REACTIVITY CONTROL SYSTEMS

CEA DROP TIME

DESCRIPTION OF AMENDMENT REQUEST

FIGURE 8
CEA EJECTION FROM 100% POWER

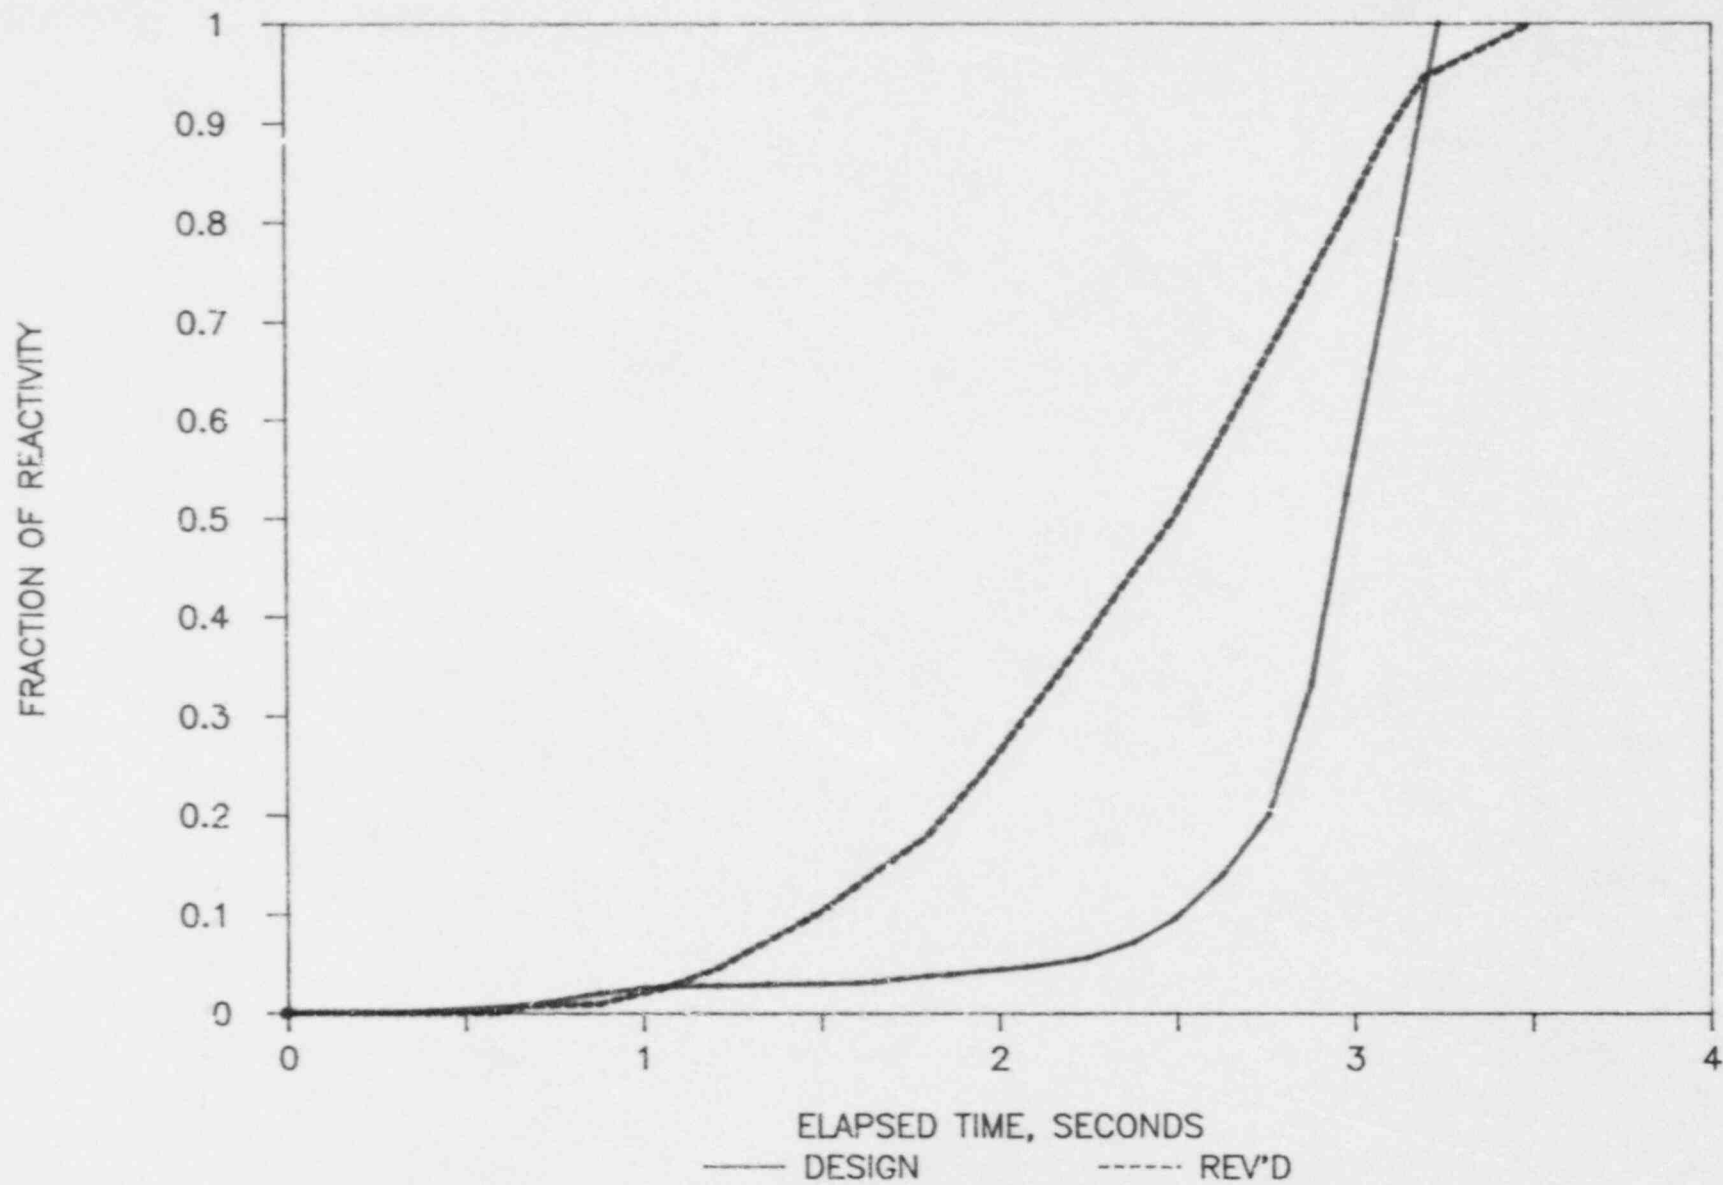
The time of maximum deposited energy occurs approximately 2.2 seconds after the trip breakers open (Figure 7.2.1-1 of Cycle 2 RAR). As shown in Table 8, and illustrated in Figure 8, the revised scram reactivity data for a total scram insertion of $5.4\% \Delta\rho$ and a -0.3 ASI (Table 7.2.1-1 of Cycle 2 RAR), at the time of interest, is more conservative than the design data. Therefore, the conclusions of this event are unchanged.
